SCHOOL DEVELOPMENT STANDARD DEPARTMENTURE ADVISORY COMMITTEE

GREEN DOT CHARTER SCHOOL WASHINGTON DESIGN DEPARTMENTURE RECOMMENDATIONS

Project #3025697

MAY 1, 2017

Exhibit 3 Proposed Building Height

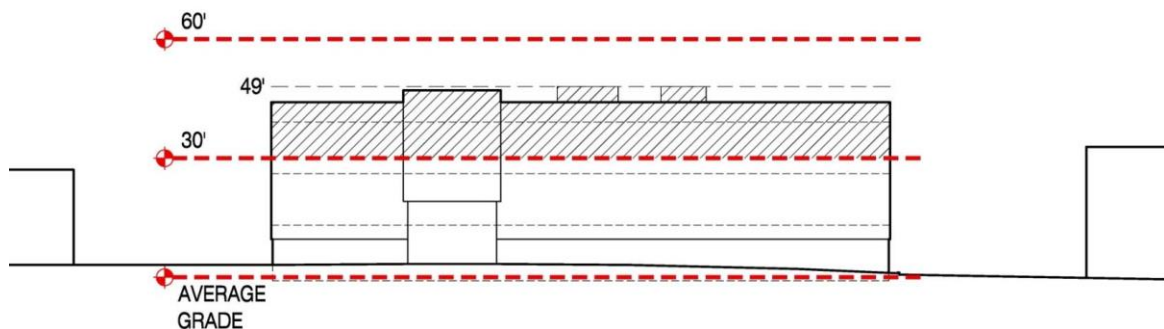
Departure Requested: To allow 19'-0" above the height limit.

- 1) A two-story building would degrade the bus and parent drop-off and pick-up, reduced play space, and not meet the needed square footage. It would also require a bigger footprint, which would be out of scale with surrounding structures. Three stories are consistent with the scale of structures in the surrounding neighborhood and is an efficient use of space as the site is located in an urban corridor.

- 3) The methods and materials used to break up the appearance of bulk is encouraged, and is already successfully executed in the staggering of those materials and the use of colors. The committee suggested other elements that the design team should explore to see the appearance of bulk be further reduced. The committee was supportive of the design and additional height of the building, and emphasized their desire to see design elements reflected in the proposed drawings be maintained through the design process. The colored rain screen at the entrances were supported, and the committee felt the additional height above 45 feet should be allowed only for elements such as these and mechanical spaces, rather than potentially raising the parapet and therefore entire building height to 49 feet. There was concern regarding the upkeep and appearance of unpainted concrete along the base of the building. In an acknowledgement to the neighboring residential properties, as well as passersbys along Rainier Ave S., the committee recommended plantings that serve as a buffer to prevent degradation of their environment.

The committee agreed that the additional height is needed for a three-story building to separate buses and parent drop-off and pick-up as well as sufficient outdoor play space.

Recommendation 1 – That the departure to allow for an additional 19 feet of height for a total of 49 feet be granted as requested by the WCSD with the following conditions:

1. **A maximum height of 45 feet for the parapet and allow the 49-foot height only for the mechanical spaces and façade enhancements.**

- 2. The design team should attempt to keep the following design elements:**
 - **Separation between horizontal bands of facade**
 - **Offset the horizontal bands that correspond with each floor**
 - **Continue to use materials that show dimension to minimize the appearance of bulk**
 - **Continue to use a contrasting color in window frames**
 - **Continue to use a contrasting color for the rain screen used at the entrances**

- 3. The design team should explore a thicker and/or contrasting color for the roof cap that would match or compliment the rain screen used at the entrances.**

- 4. Pursue a clear anti-graffiti coating to avoid painting the cast concrete base in the future.**

- 5. Plant and maintain plantings as shown and irrigated to provide scale and serve as a buffer, most importantly at the frontage along Rainier Ave S and where the site abuts residential neighbors.**
